STAFF REPORT 11/9/2022

SUBJECT: Tripoli Mixed-Use Project (Proposed Revisions)

SPECIFICS: Amendments to Conditional Use Permit (CUP) 351 and Architectural Review (AR) 22-04 for the PUD (Planned Unit Development) Overlay Zone guidelines, design revisions and modifications to conditions of approval for a mixed-use development consisting of 108 apartment units and 2 retail units on 2.8 acres of vacant C-G (General Commercial) zoned property at the northeast corner of Cesar Chavez Street and Bagdad Avenue (APN# 778-081-003 and -001) Applicant: Chelsea Investment Corporation

Figure 1: Site Plan (Original)

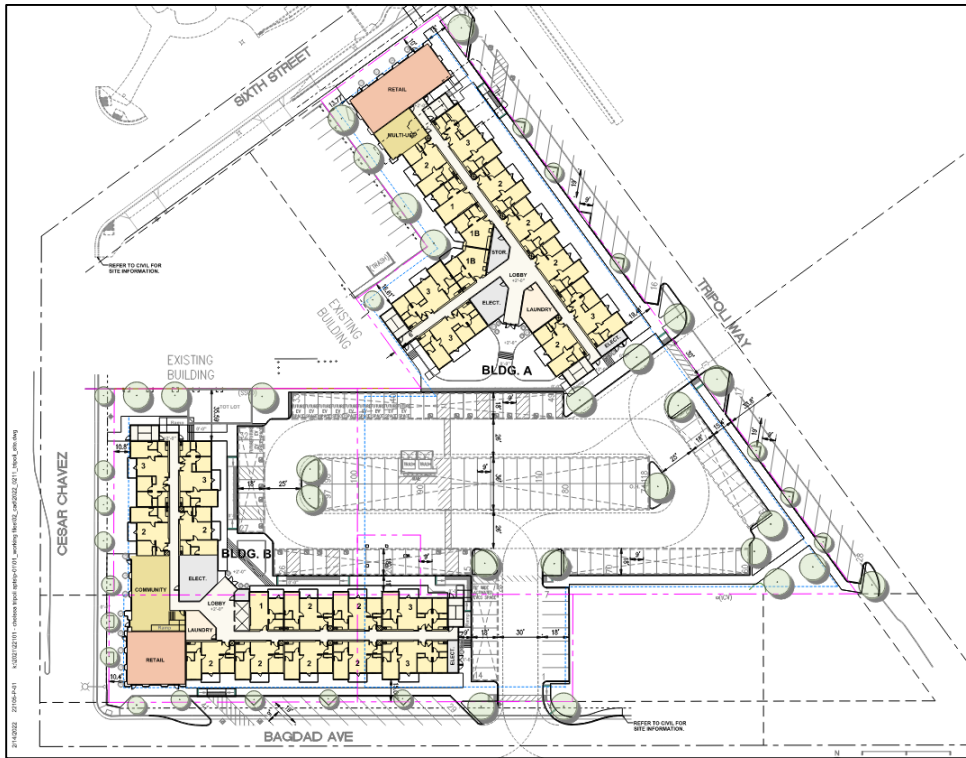
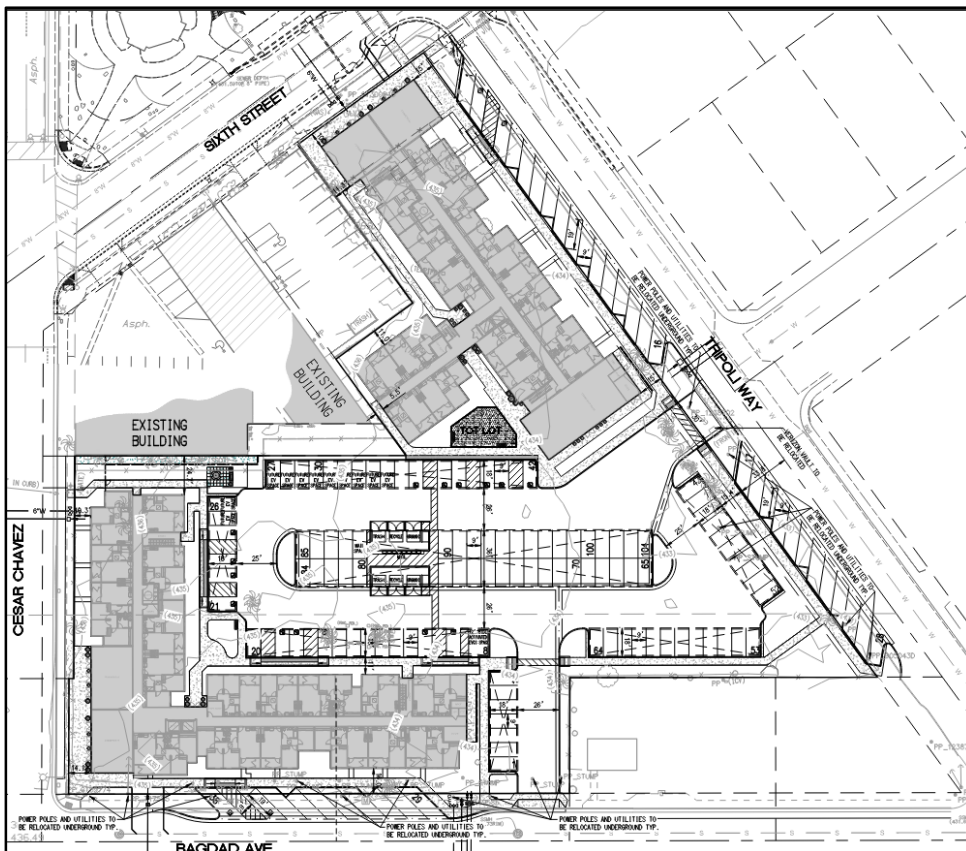
The applicant proposes modification of an approved mixed-use development consisting of 108 apartment units and 2 retail spaces within 2 buildings in the Pueblo Viejo District. Building A was approved for a 3-story; 49,794 sq. ft. building located toward the Southwest corner of 6th Street and Tripoli Avenue. Building B was approved as a 4-story, 71,079 sq. ft. building located toward the Northeast corner of Bagdad Avenue and Cesar Chavez Street. Both buildings would be constructed near property line with building frontages on 6th Street, Tripoli Way, Bagdad Avenue and Cesar Chavez Street and on-site parking oriented behind the buildings consistent with goals of the Pueblo Viejo Revitalization Plan. The orientation of the buildings support the City's goals of promoting a walkable downtown environment with a well-designed public realm.

The applicant proposes to maintain the same unit count of 108 apartments with 1-3 bedroom unit options, but proposes to reduce the size of all units and the unit number in Building B in order to reduce the size of Building B to 54,981 sq. ft. and reduce the number of stories from 4-stories to 3-stories. The community lounge space is proposed to be merged into Building A and total community lounge space increased by 252 sq. ft. The community space will include kitchen space,

restrooms, and 6 computer stations. The retail space available for the project would increase by 1,827 sq. ft. under the new proposal with two retail suites in each building.
